**Rezoning from "Residential (Group C) 2" ("R(C)2") and "Open Space" ("O") zones to
"R(C)4" zone for a Proposed Residential Development
at Lot Nos. 519 RP (part) and 520 RP in D.D. 110 and adjoining Government land,
and
Rezoning from "R(C)2" to "O" zone
at Lot Nos. 121, 137, 138, 139 S.A and 139 RP (part) in D.D. 110
and adjoining Government land, Shek Kong, Yuen Long, N.T.
(S12A Amendment of Plan Application No. Y/YL-KTN/6)
- Further Information No. 3 -**

Proposed Rezoning of the Application Site from (i) “Residential (Group C) 2” and “Open Space “ Zones to “Residential (Group C) 4” Zone for a Proposed Residential Development at Lot Nos. 519 RP (part) and 520 RP in D.D. 110 and adjoining Government land and (ii) from “Residential (Group C) 2” to “Open Space” Zones at Lot Nos. 121, 137, 138, 139 S.A and 139 RP (part) in D.D. 110 and adjoining Government land at Shek Kong, Yuen Long, N.T. (S12A Amendment of Plan Application No. Y/YL-KTN/6)

Comments Forwarded from Fanling, Sheung Shui and Yuen Long East District Planning Office (FSS&YLE DPO)

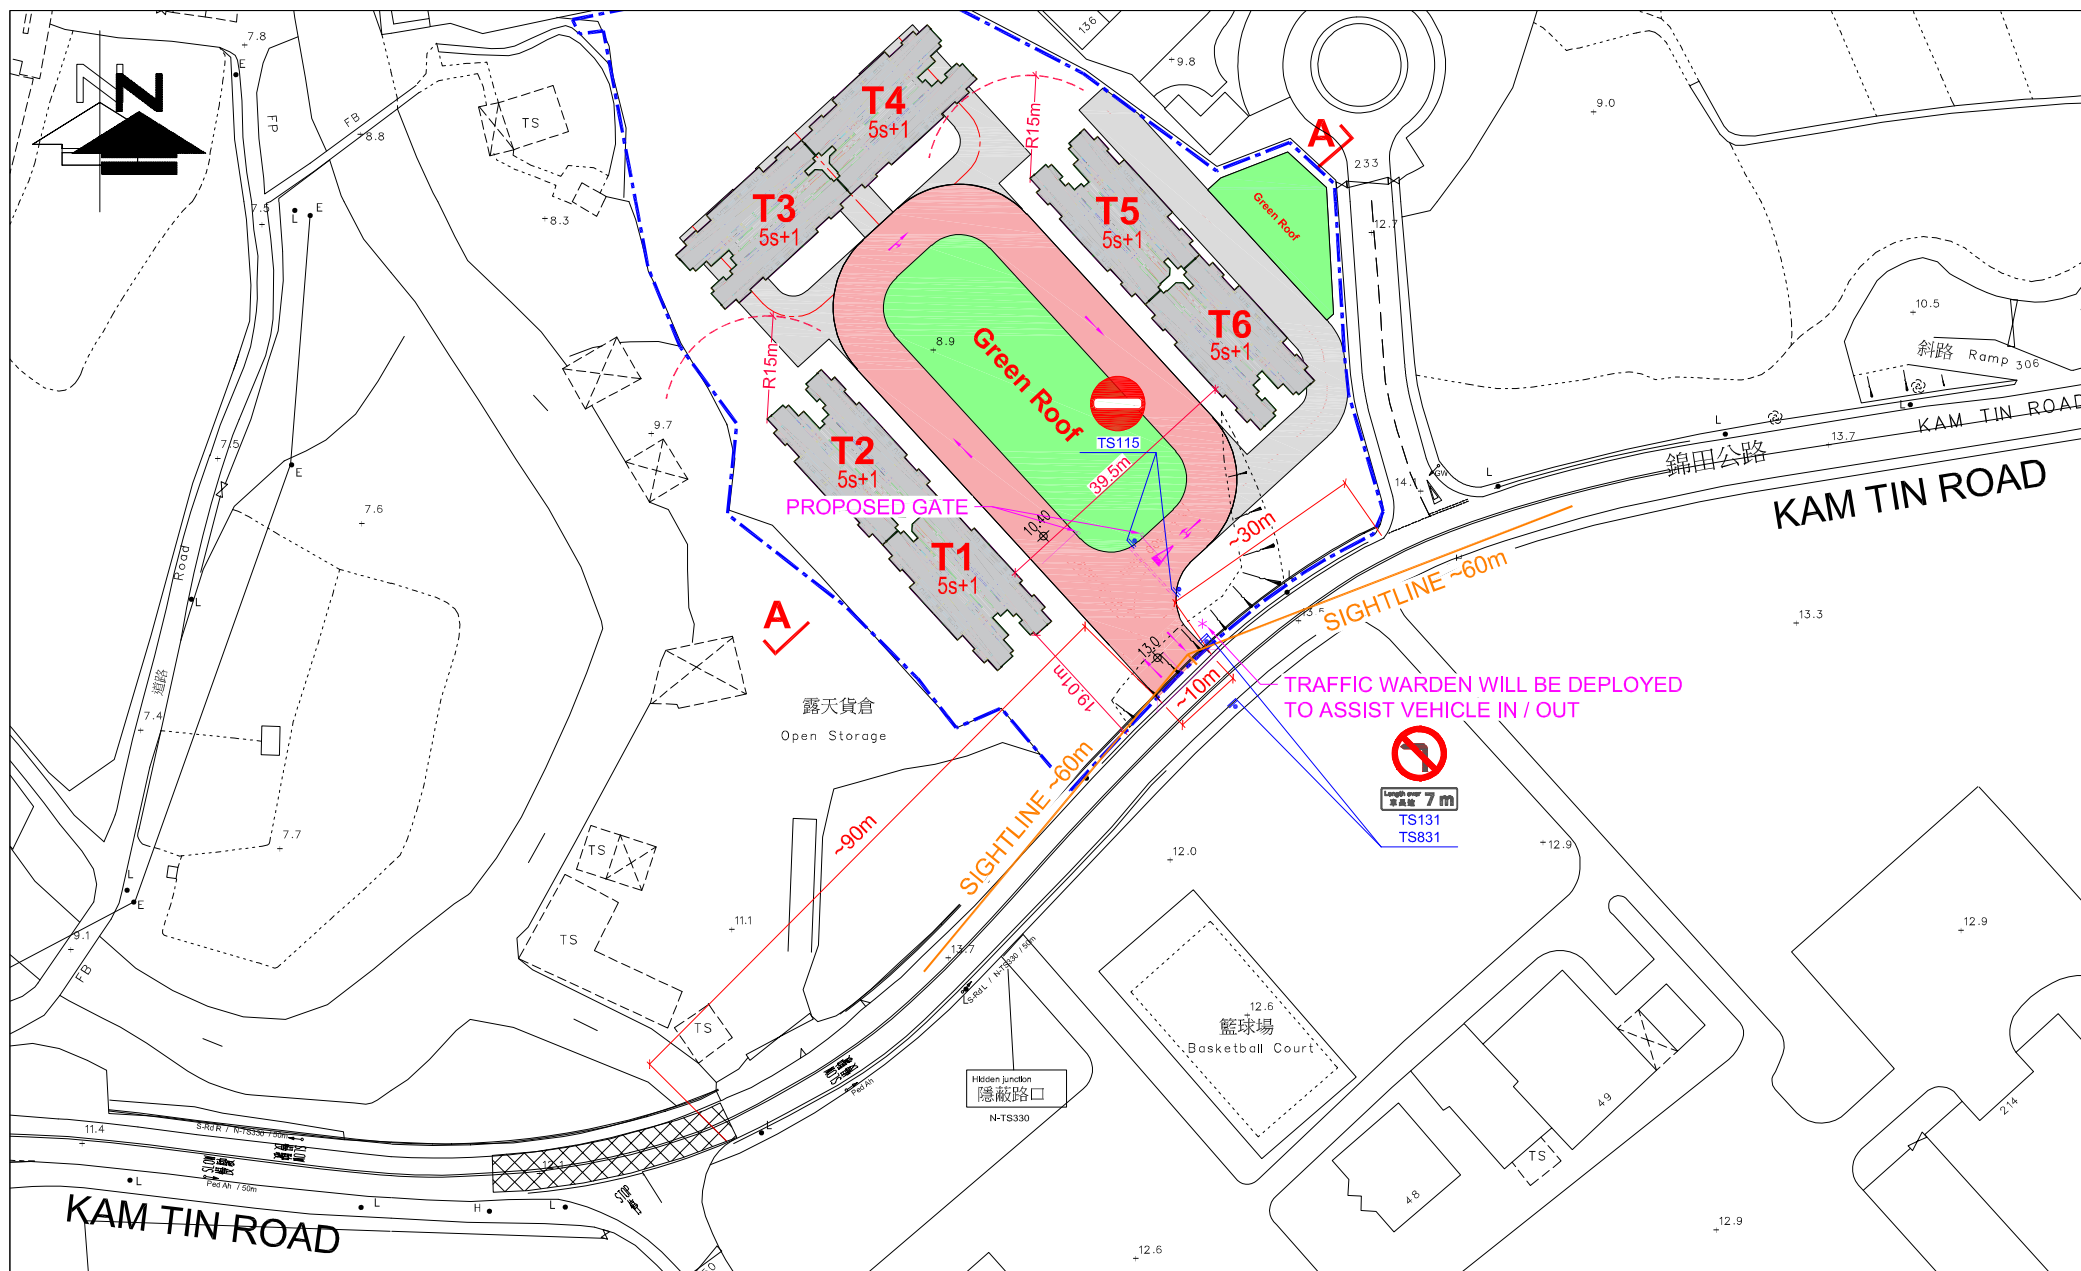
8. Figure 2.1 - the distance between the development run-in/out and the nearest junction shall be indicated. The applicant should also advise whether this could fulfill the requirement in TPDM.	The distance between the development run-in/out and the nearest junction (Kam Tin Road/ Avenue De Versailles) are shown in Figure 2.1 of the TIA report. The distance is min. 30m, which fulfills the requirement in TPDM.

7) Figure 2.1 - the junction of the internal road and the proposed ingress / egress is very close. The applicant should advise whether this could compile with TPDM and should further demonstrate the traffic management in this location with sufficient details on how to prevent vehicles queuing back to public road. Given the size of the ingress / egress, central island should be considered to assist pedestrians crossing the access.	To avoid oversized access, run-in/out will be used rather than access road arrangement. Thus, no central island is needed. The access arrangement has been revised and is shown in Figures 2.1 (Without Kam Tin Road Widening) and 2.2 (With Kam Tin Road Widening). The swept paths are shown in Figures 2.1 (SP1) to 2.1 (SP5) (Without Kam Tin Road Widening) and Figures 2.2 (SP1) to 2.2 (SP5) (With Kam Tin Road Widening). As shown in the swept paths, most of the vehicles can ingress and egress simultaneously, except for vehicles longer than 7m. To minimize the impact on the public road, one-way traffic flow will be adopted for the internal road. Ingress traffic cannot turn right but go straight inward to reduce conflicts with the egress traffic. Separate gates will be provided for ingress and egress traffic. The waiting area before the ingress gate could hold about 1 HGV plus 1 PV/LGV to avoid queuing back to public road. Ingress traffic has priority to enter the proposed development. When long vehicles enter the proposed development, egress traffic must wait behind the egress gate

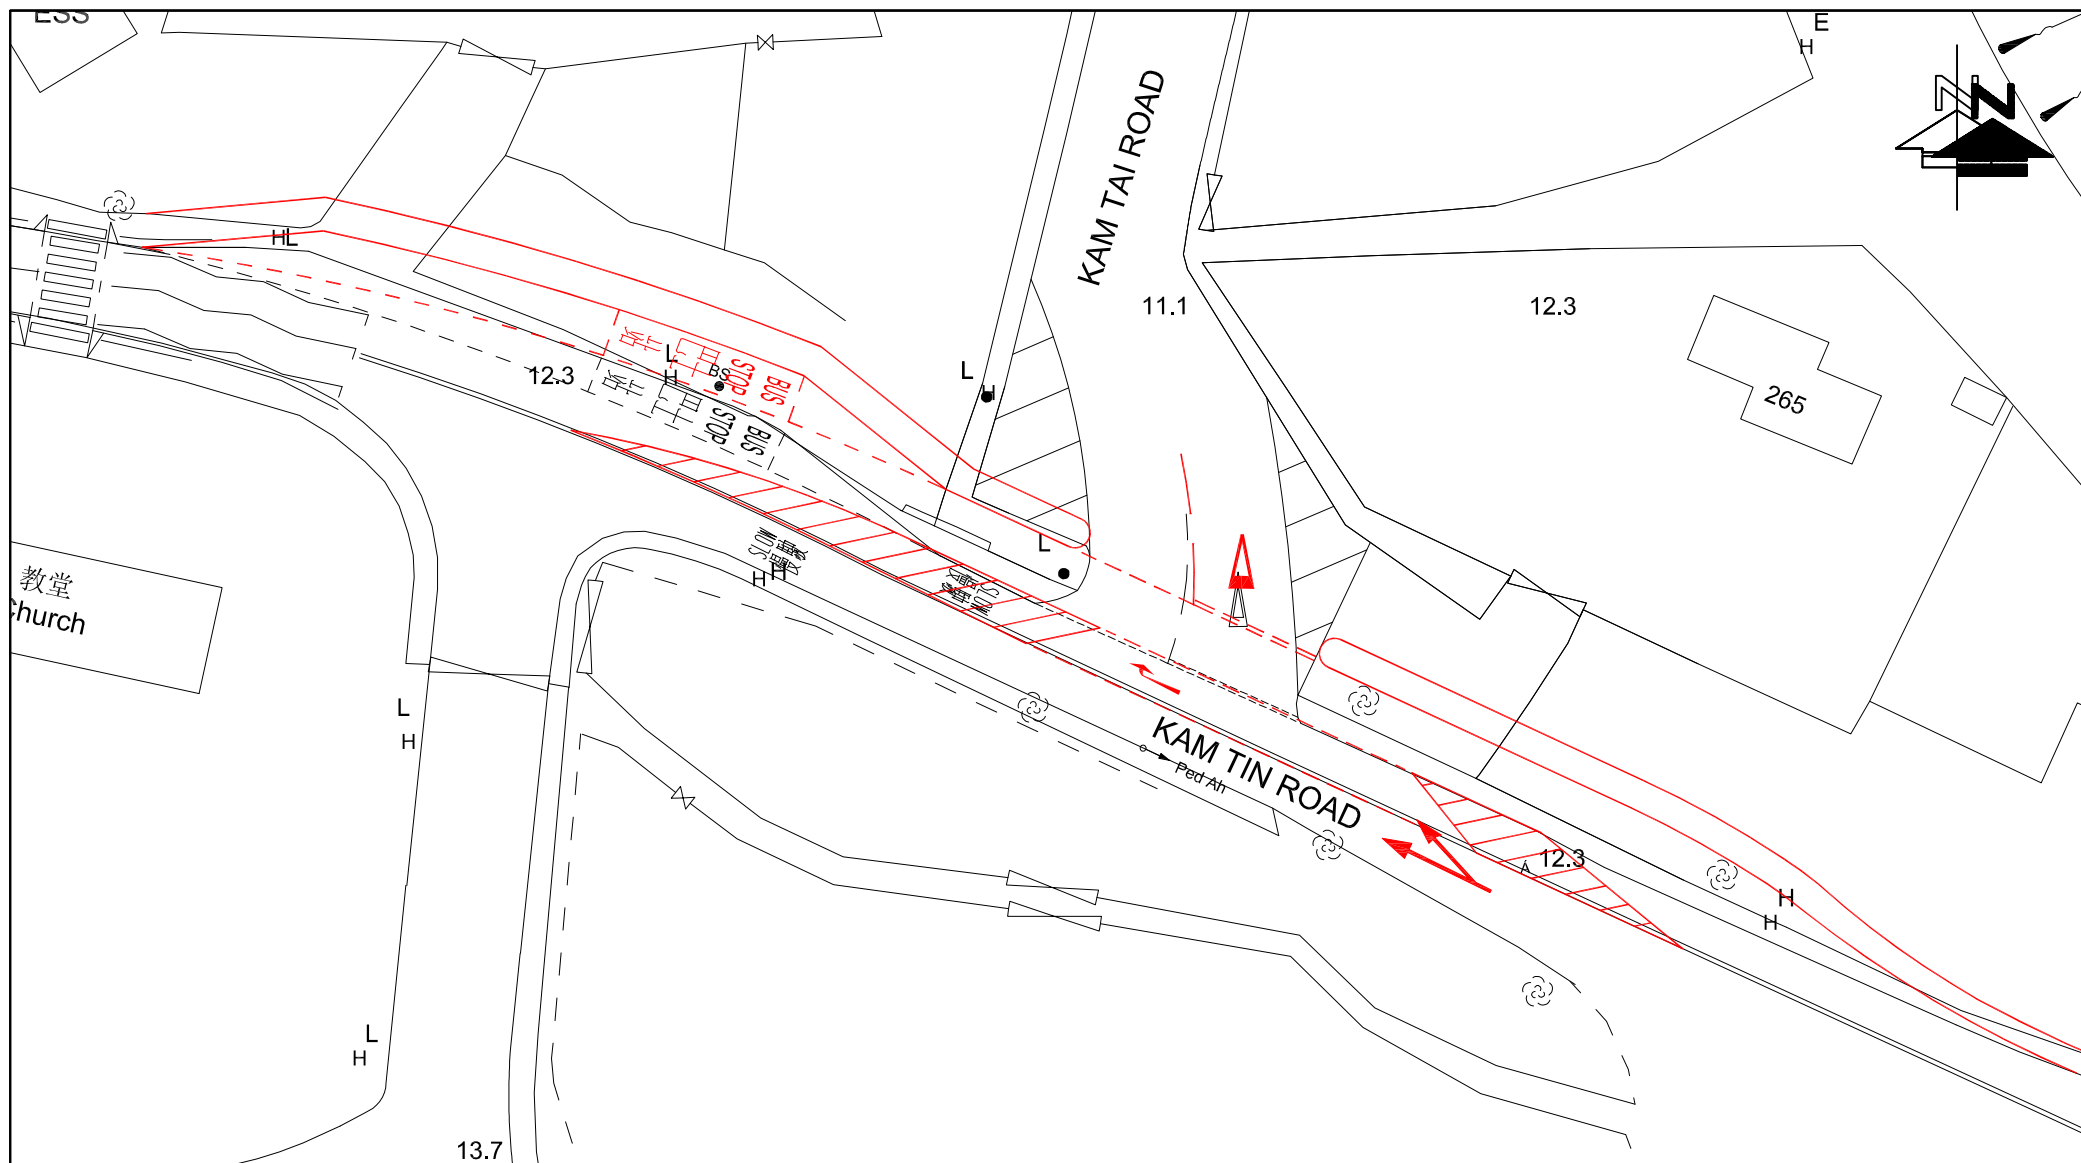
9. Figure 5.1 - in general the proposed improvement works ties in with the development, e.g. population intake, BC date etc, but not a public works. Please demonstrate when the improvement work would be carried out.	The improvement works will be carried out and completed before the population intake of the proposed development, in case of programme mis-match between the development and the public works project.
Comments from Transport Department (received on 19 March 2026) Contact person: Mr. Phil CAI; Tel. No.: 2399 2421

- Regarding the details of the proposed road improvement works at Junction C to be implemented by the Applicant in case of program mis-match between the proposed development and the public works project, Kam Tin Road will be widened locally from about 6m to about 10m and a right-turn pocket will be added to allow traffic to wait and turn from Kam Tin Road westbound into Kam Tai Road. The existing bus lay-by and bus stop will be shifted to the north to cater for the widening. For details, please refer to Figure 5.1 of the TIA report.

Proposed Drainage System

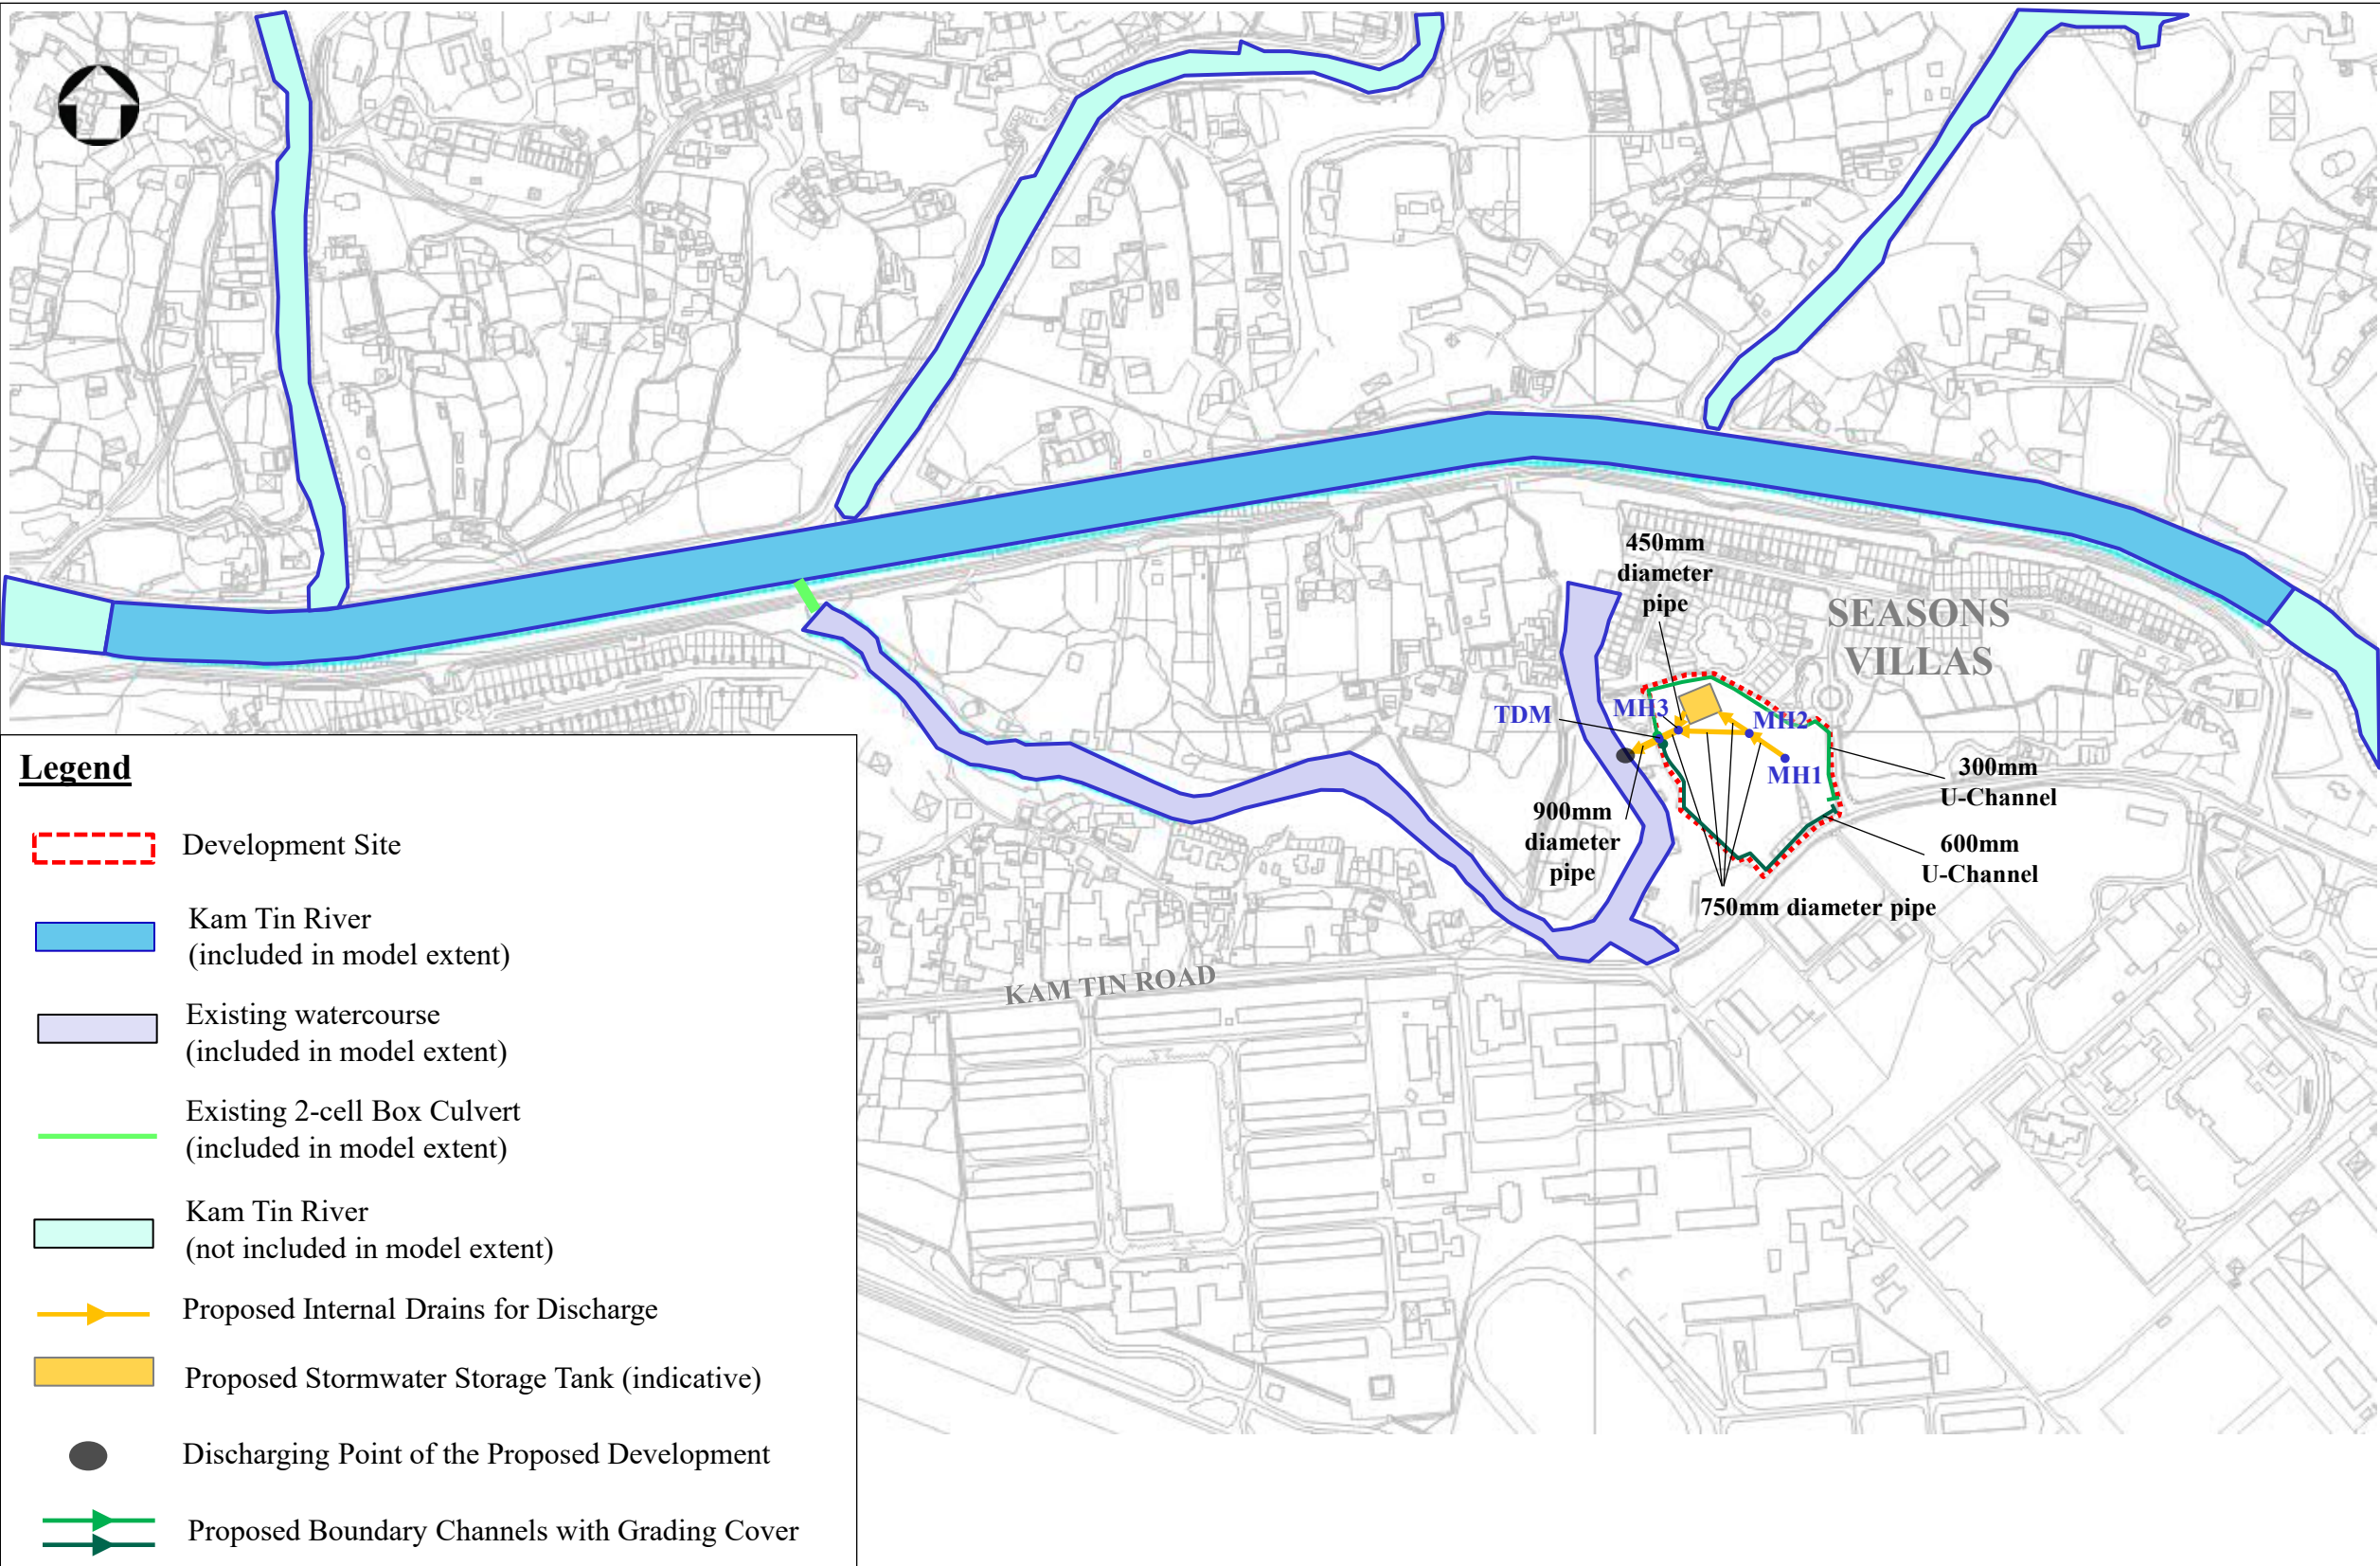
2. The applicant should clarify discrepancy of invert levels of the proposed 300 mm and 600 mm dia. stormwater drainage pipes shown on the submitted drainage plan and pipe schedule. The applicant should update the submitted hydraulic calculation in Appendix I.	The invert levels of the proposed 300 mm and 600 mm dia. stormwater drainage pipes are revised in Appendix B2. Appendix I is updated to include the hydraulic calculation of the proposed 300mm pipe.

Comments	Responses
3. The applicant should clarify size of the proposed stormwater pipe shown in the proposed connection details of existing watercourse and the proposed stormwater terminal manhole TDM	The proposed stormwater pipe connecting the proposed stormwater terminal manhole is 900mm diameter. The pipe sizes shown in the typical drainage outlet in Appendix B2 are updated.

5. The DTL of the proposed stormwater terminal manhole should be indicated on the drawing complying with the current Government standard and a 150mm difference between I.L. and D.T.I.L. should be maintained.	The proposed stormwater terminal manhole will comply with the current Government standard and have a 150mm difference between I.L and D.T.I.L of the proposed stormwater terminal manhole (i.e. TDM in Appendix B2). The invert levels of the incoming pipes of TDM are 6.75mPD for proposed 300mm pipe, 6.73mPD for proposed 600mm pipe and 6.675mPD for proposed 750mm. The D.T.I.L of the outgoing pipe of TDM has been set at 6.525mPD, providing the required 150 mm difference between the lowest I.L. (6.675mPD) and the D.T.I.L. (6.525mPD). The information has been provided in Appendix B2.
